POLLO CAMPERO - SoDo (RE-INSTALLATION OF DRIVE-THROUGH)

Applicant's Request: The applicant requests Conditional Use Permit (CUP) approval to convert the existing Five Guys restaurant into a new Pollo Campero restaurant with a drive-through window. Location within the So-Do Special Plan Overlay requires the CUP request for the drive-through lane.

Staff's Recommendation: Approval of the Conditional Use Permit, subject to the conditions in this report.

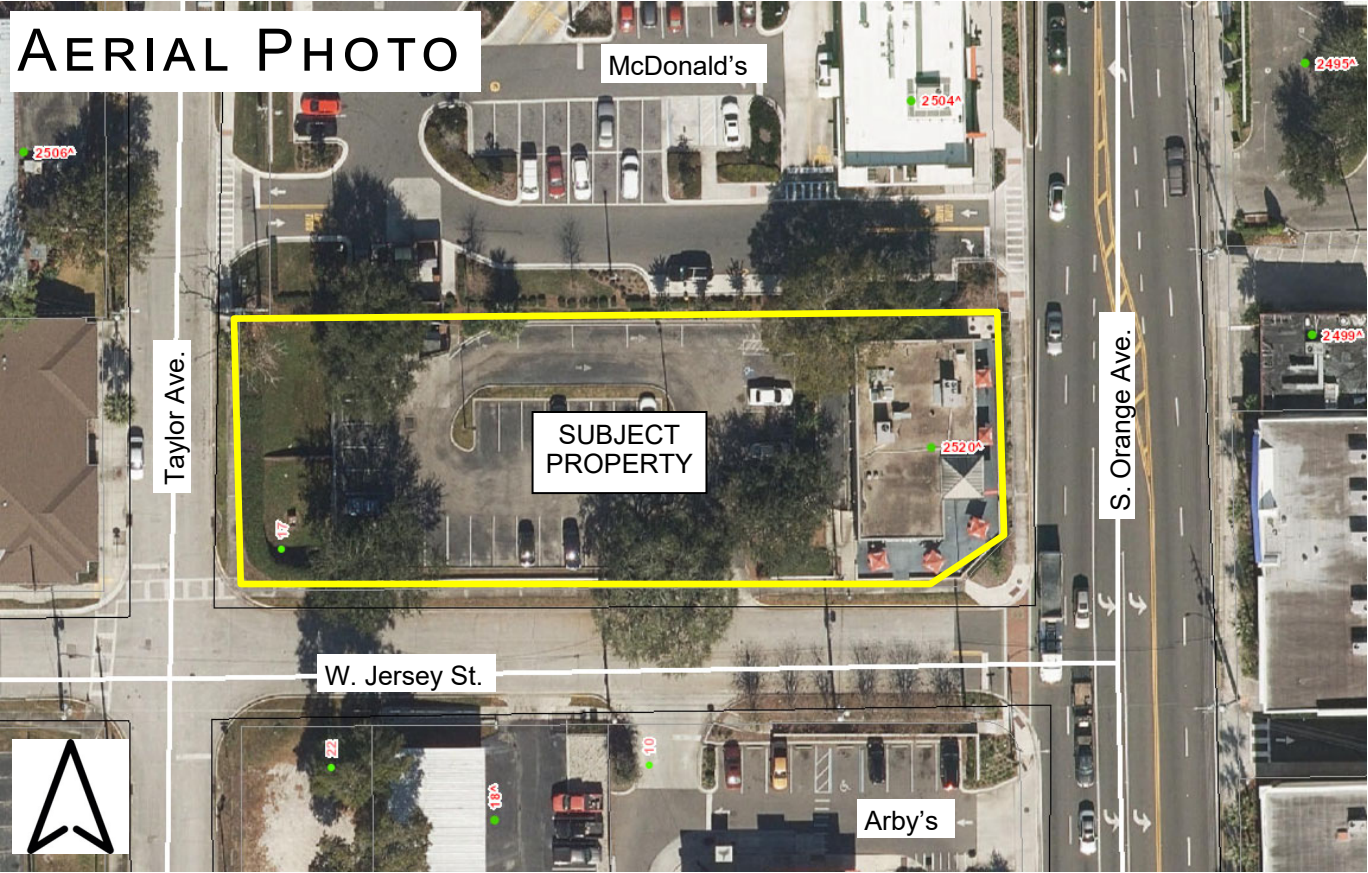
Solid Waste: A dumpster enclosure is shown in the north rear portion of the parking lot, with ample backup space for the refuse truck.

Sewer/Water Reclamation: The building is already connected to existing sewer mains. Stormwater will be directed to an existing stormwater pond on the far west end of the site.
